ADDENDUM NO. 1

February 16, 2024

Yorktown High School – Addition and Renovations 1100 South Tiger Drive Yorktown, IN, 47396

ADDENDUM

DRAWING TITLE: LIFE SAFETY PLAN - UNIT F

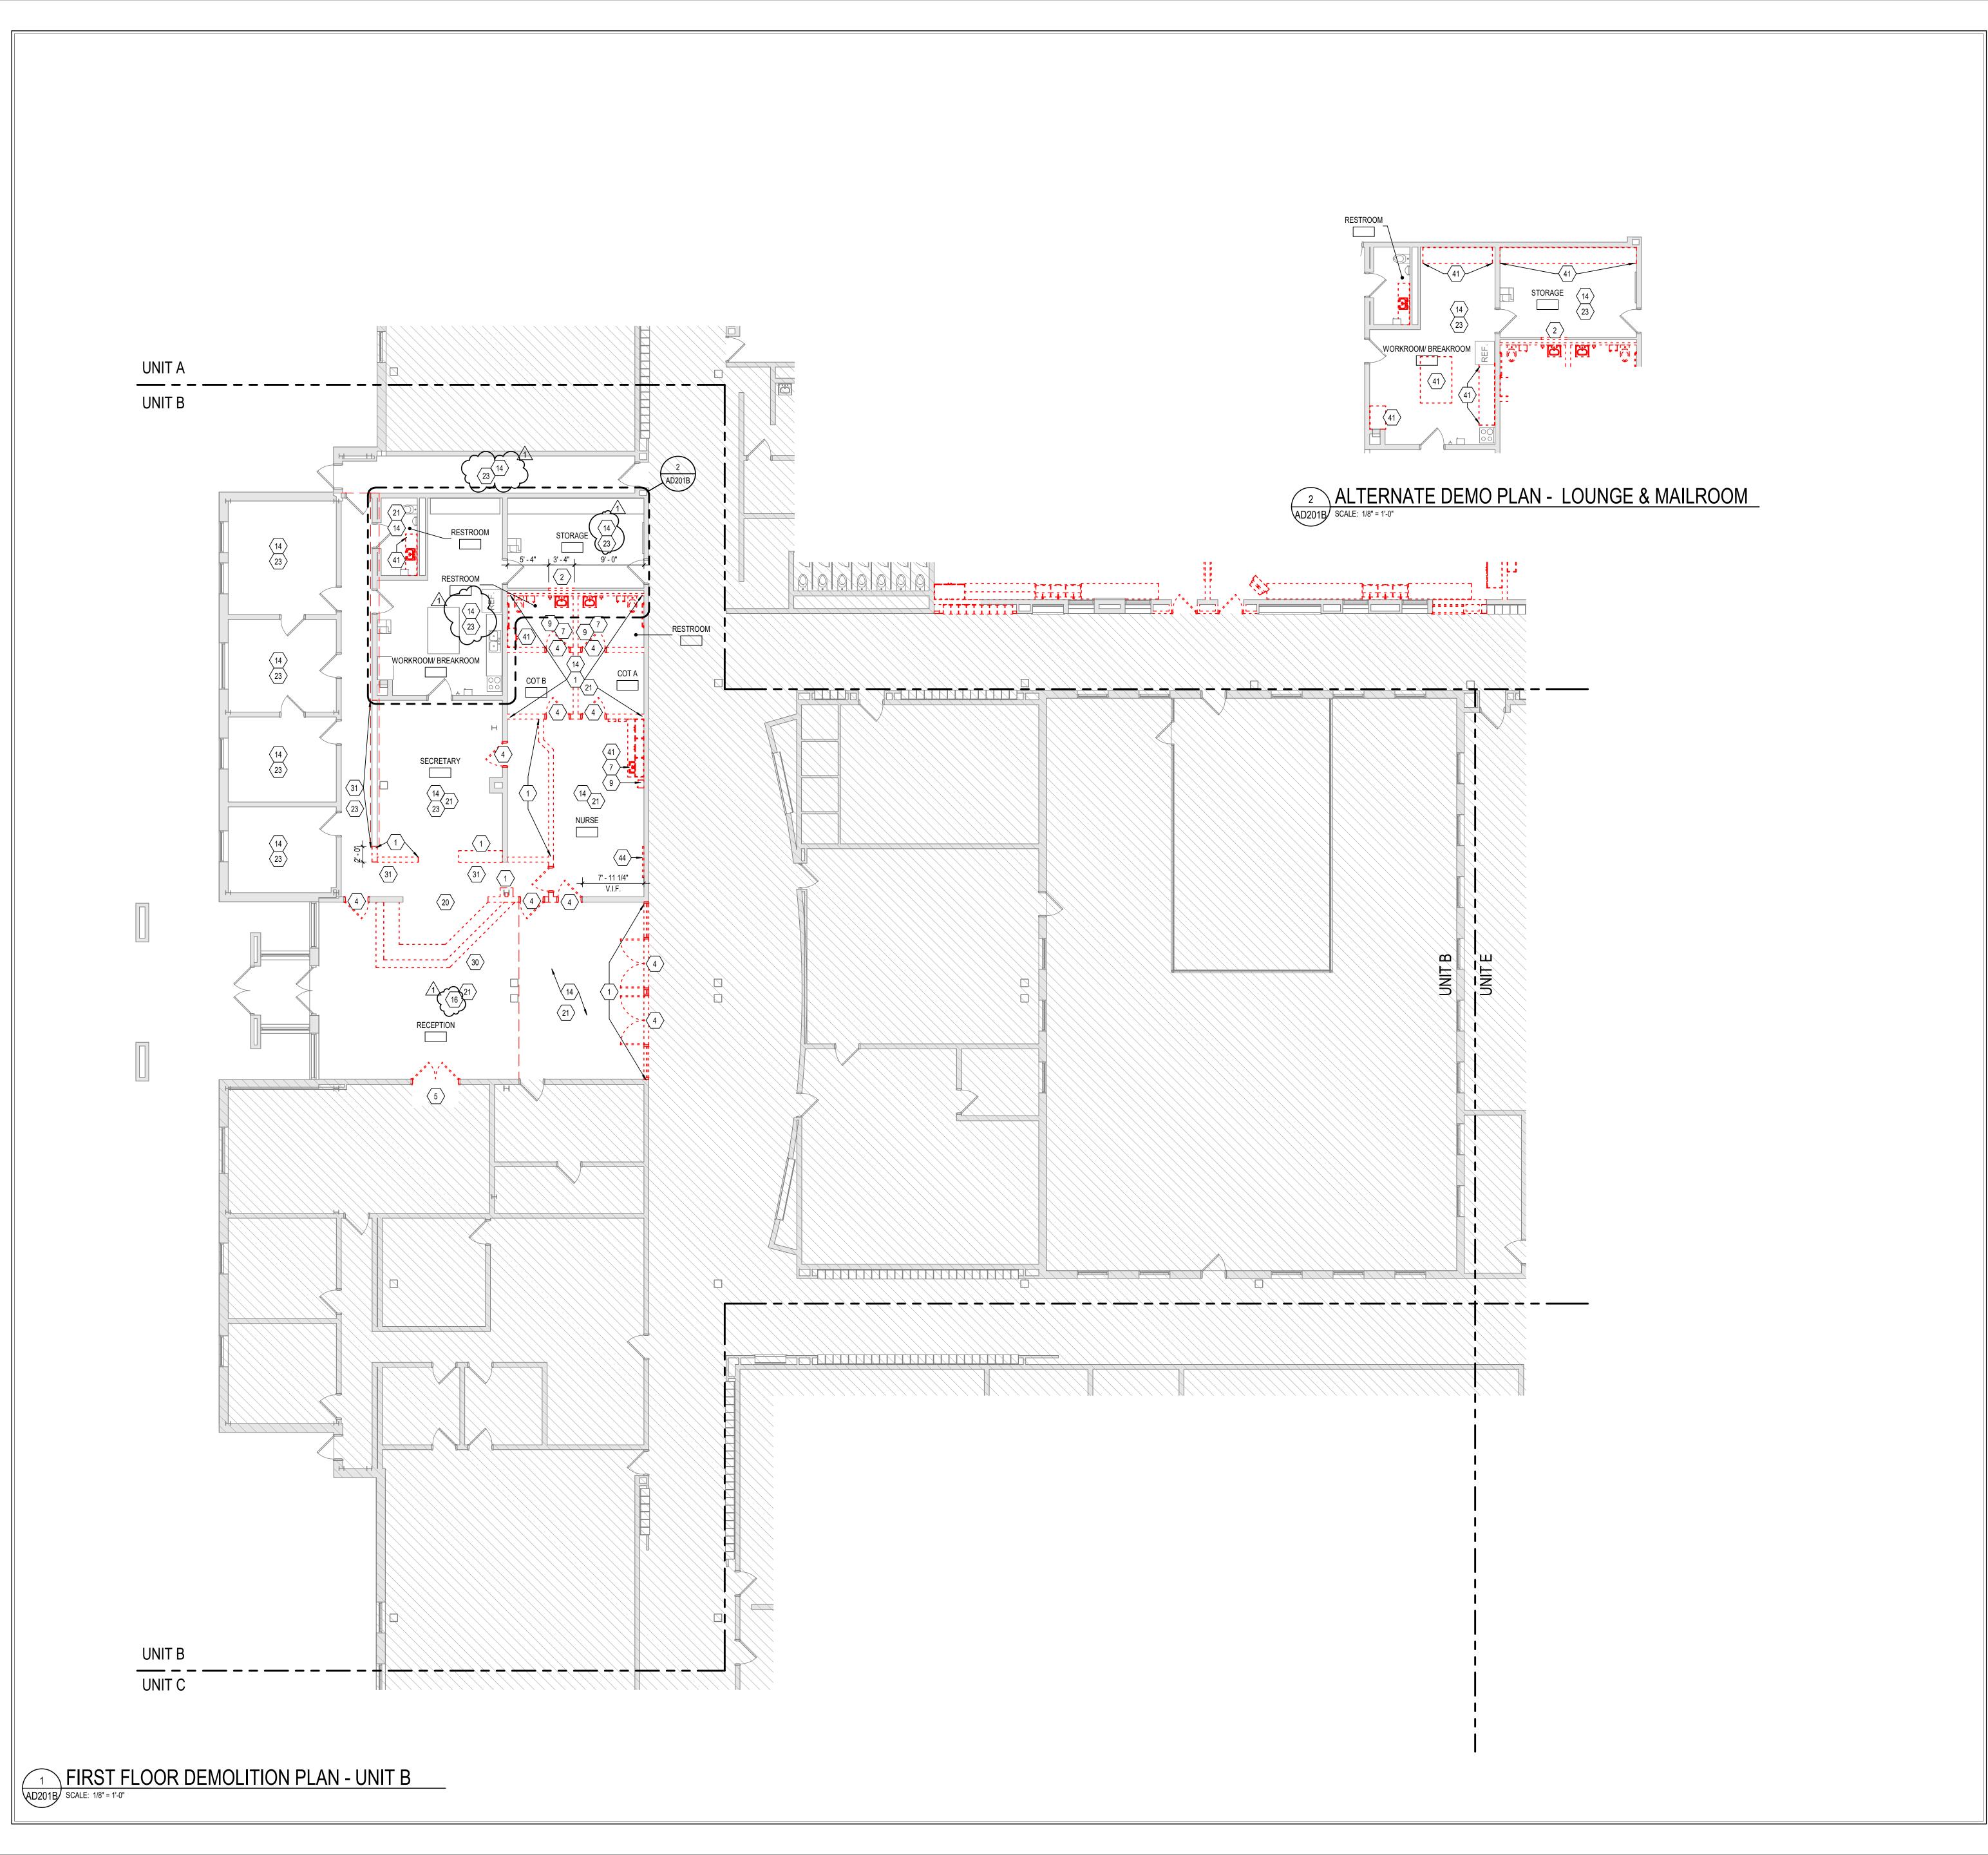
3.2 <u>A111 – LIFE SAFETY PLAN – UNIT F</u>

DRAWING NUMBER
AD201B

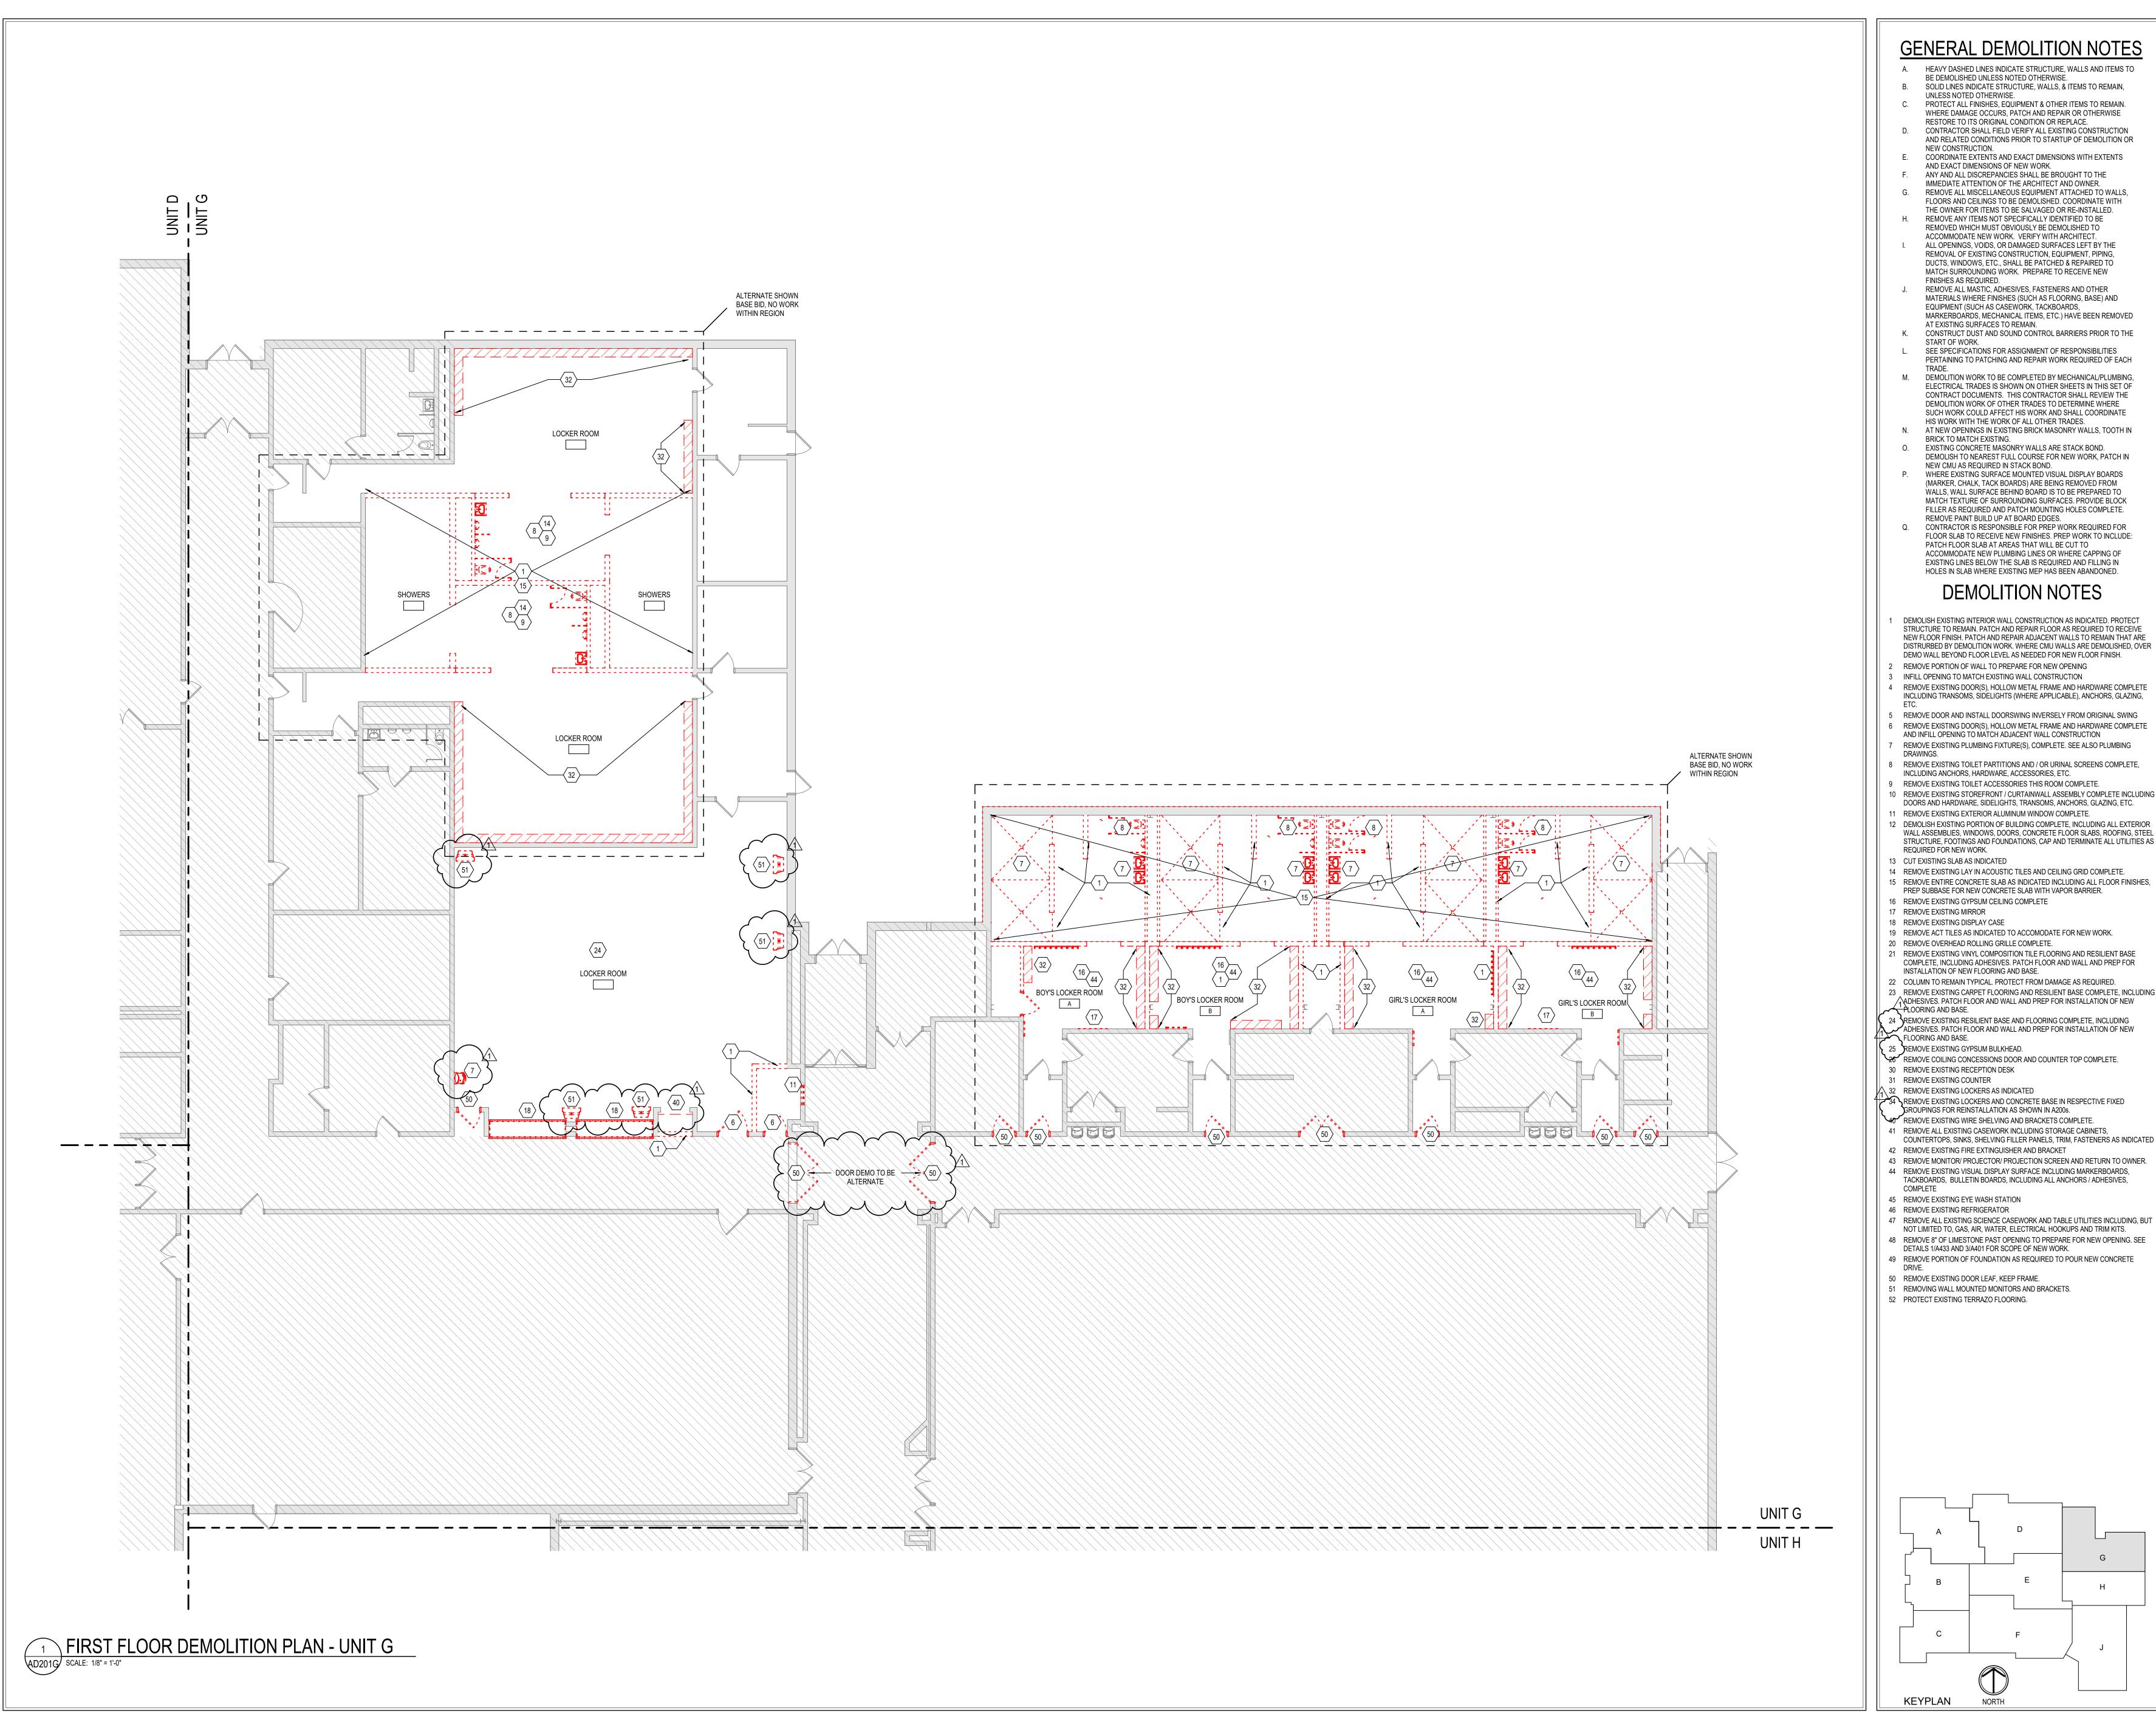
3.3 <u>AD101B – FIRST FLOOR DEMOLITION PLAN – UNIT B</u>

- A. Add Demo Note 14 and 23 in Breakroom, Hallway, and Storage Room.
- B. Revise tag for the ceiling in Reception from Demo Note #14 to **Demo Note #16.**

AD201G PROJECT NUMBER 2022016

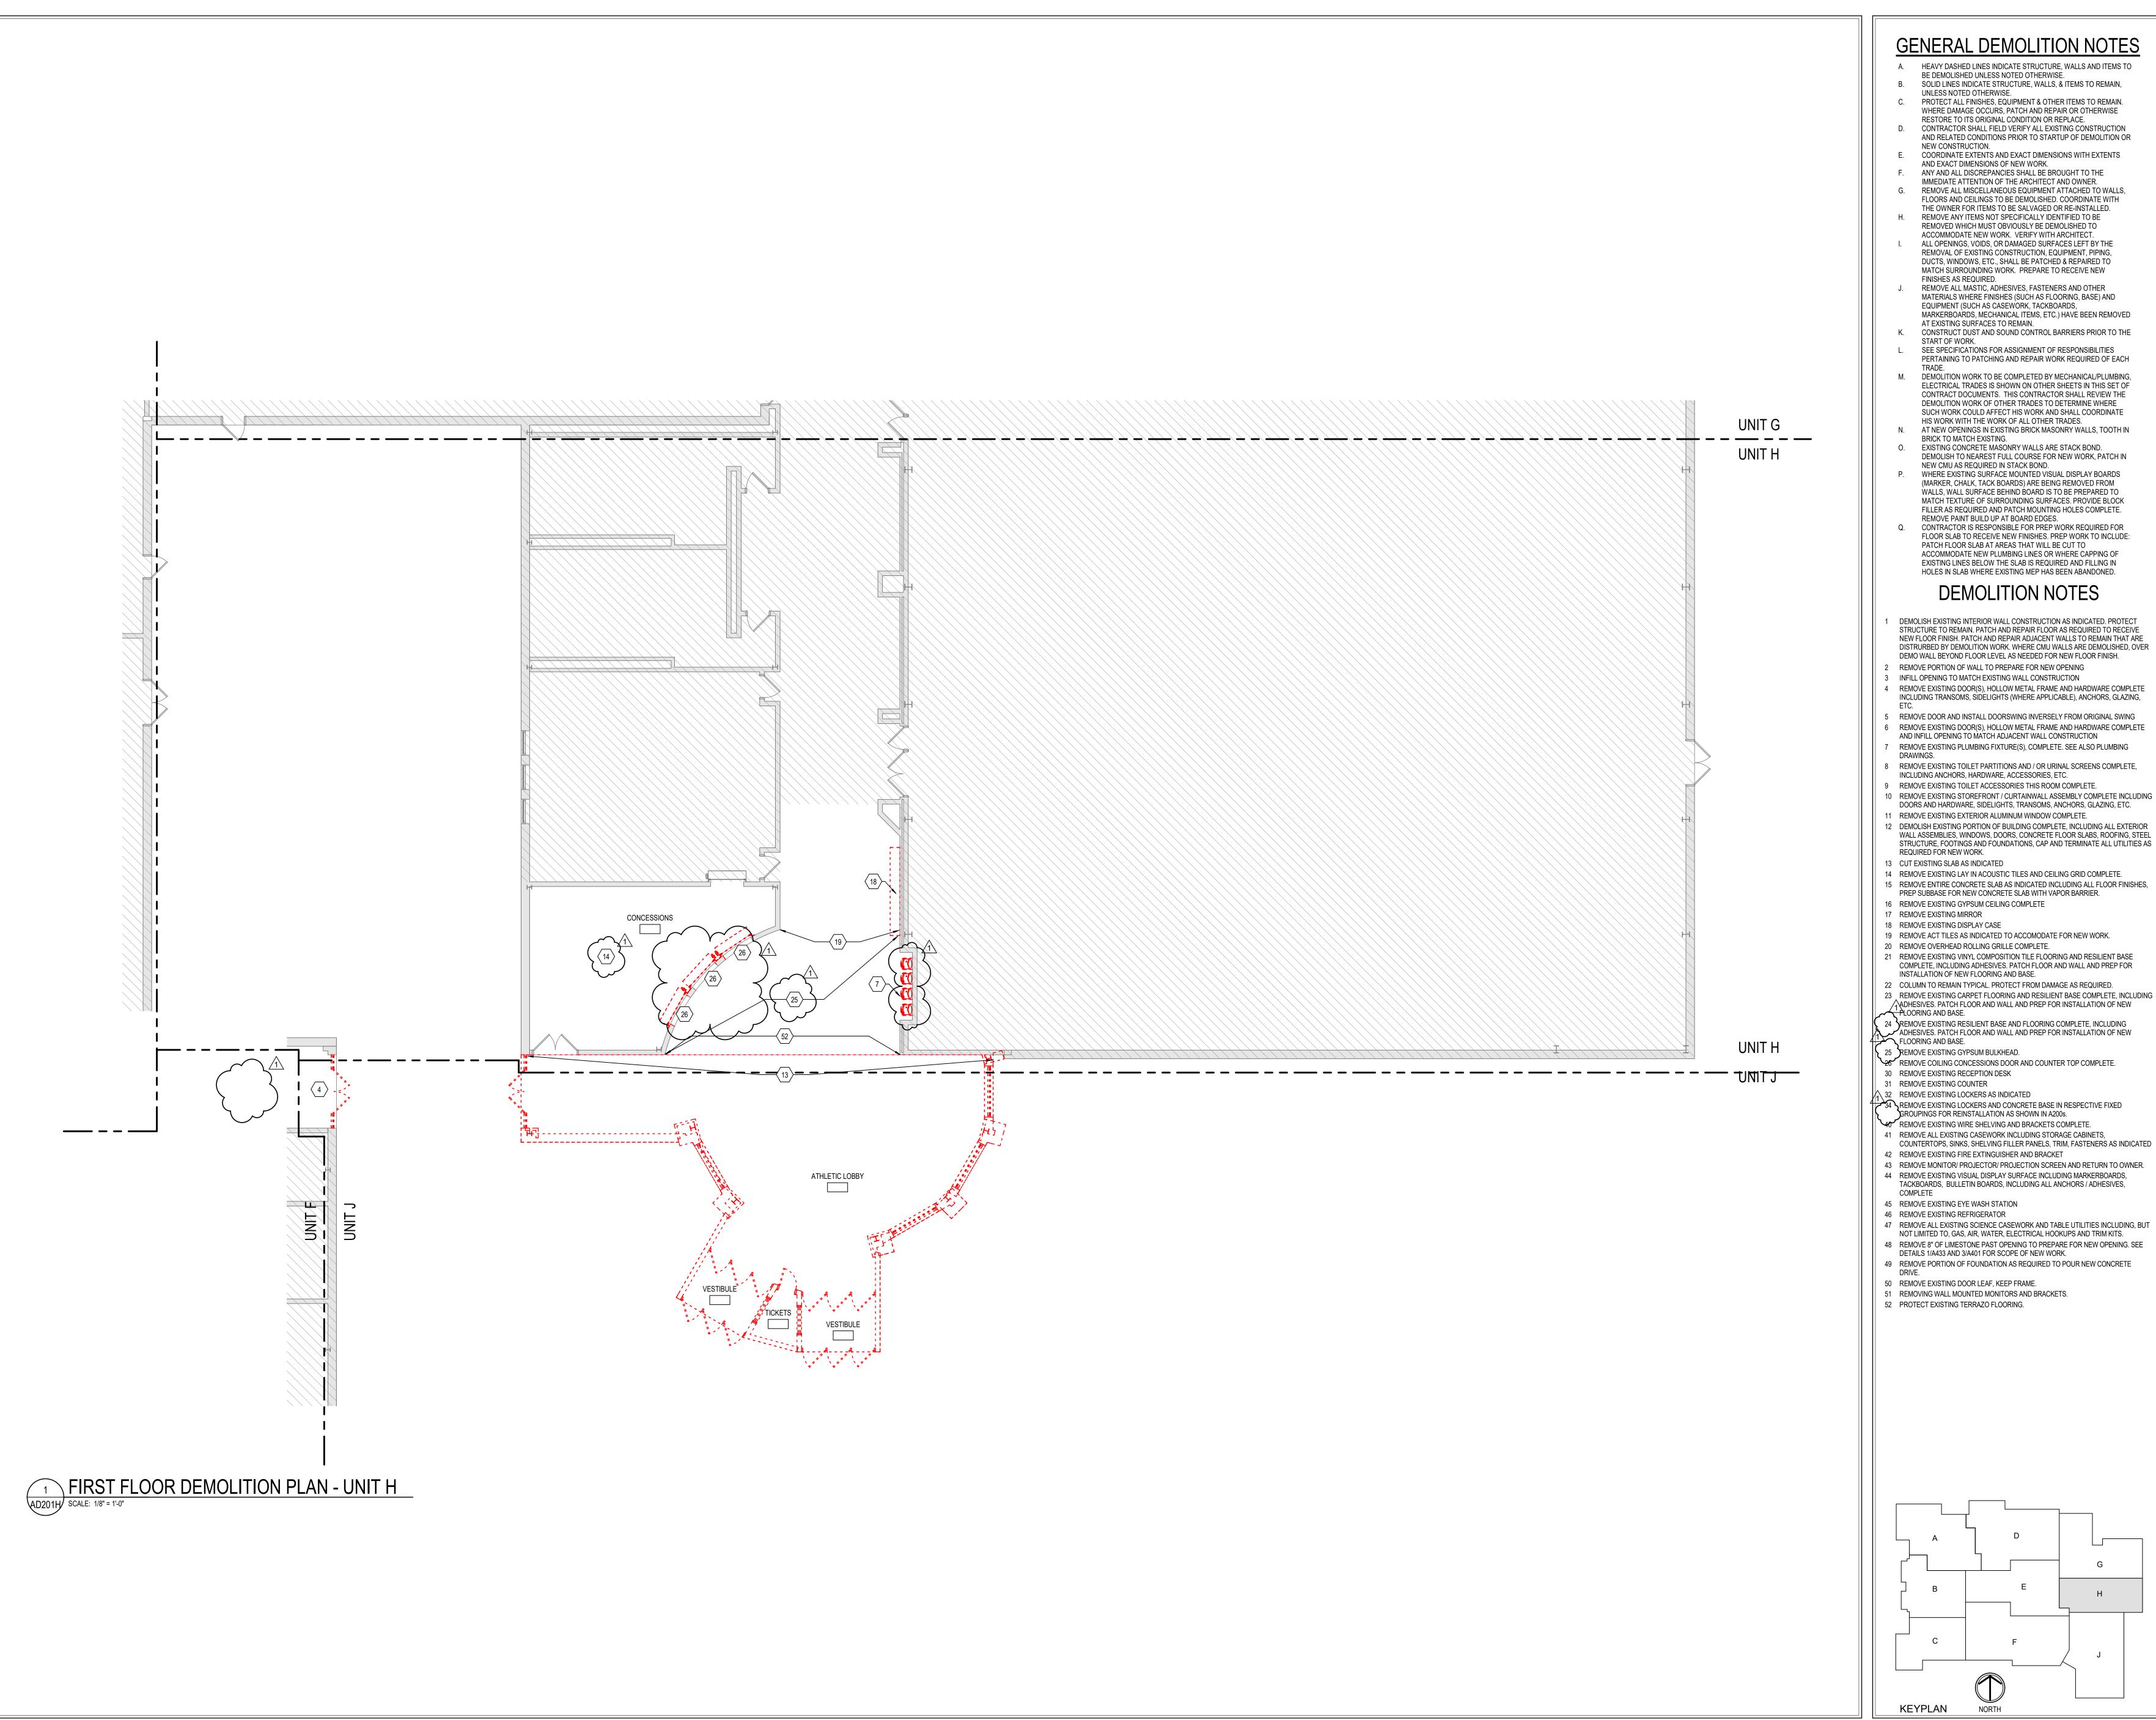
3.4 <u>AD201G – FIRST FLOOR DEMOLITION PLAN – UNIT G</u>

- A. Revise Demo Note #24 to include **FLOORING** to be removed, typical all locations.
- B. Add Demo Note #40 REMOVE EXISTING WIRE SHELF AND BRACKETS COMPLETE.
- C. Identified demolition of water fountain, shelving, and TVs.
- D. Indicate additional area of Alternate Bid.
